Overview: The initial production release of the FTI-NSP2 harness has an issue where the POC1 circuit is incorrectly positioned in the CM7 I/O connector. This issue affects only the gray 20-pin CM7 I/O connector illustrated below in figure 1.

Figure 1: Incorrect placement

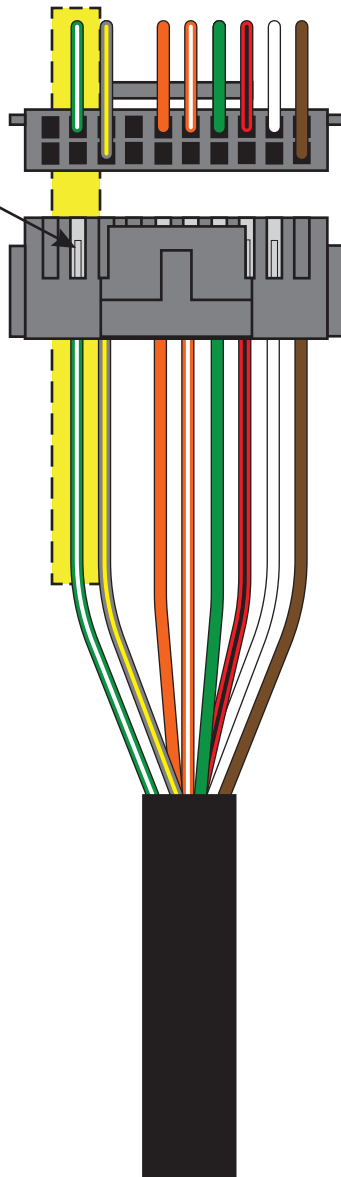
Issue: The green/white parking light circuit is positioned in pin position #17, the fixed light output where the green/white wire is typically placed for parking lights, but the harness solution uses the vehicle hazard lights instead, the result when used as supplied is an erratic light display.

- 1.) Use a pick tool to depress the locking tab on the terminal connector of the green/white wire
- 2.) Remove wire and prepare to reposition
- 3.) Once removed, reposition the locking tab by using a razor knife to lift the tab into a usable position
- 4.) With locking tab repositioned, relocate to pin position #1 (top right position as illustrated)
- 5.) Push the terminal connector into the I/O connector housing until the locking tab clicks into place and the wire is secure
- 6.) Correction complete, you may now complete the installation, but remember to configure POC1 for Hazards (setting #30)
